INDESIT company

MBM1722VFR

F043309

Technical Documentation guidelines

N1030093fig1

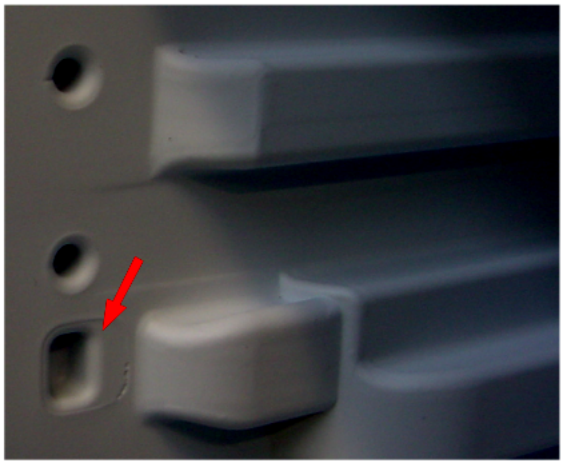
n1030093: New fixing of evaporator on static fridge-freezers (05 range) 60 cm,Melano

From August 05 (serial no. 50802.0001) the freezer evaporator is secured to the cabinet by a plastic profile.
The cabinet walls have been modified to create locations to house the profile, which is installed on the front of each evaporator plate (see photo N1030093fig1- fig2 - fig3)
The profile cannot be fitted on premodification appliances, so technical personnel must continue to fit the rh and lh supports on these models (see photo N1030093fig4)

New parts
C00141135 = WHITE PROFILE L=443.5 MM

Parts replaced
C00075596 = EVAPORATOR RH SUPPORT
C00075597 = EVAPORATOR LH SUPPORT
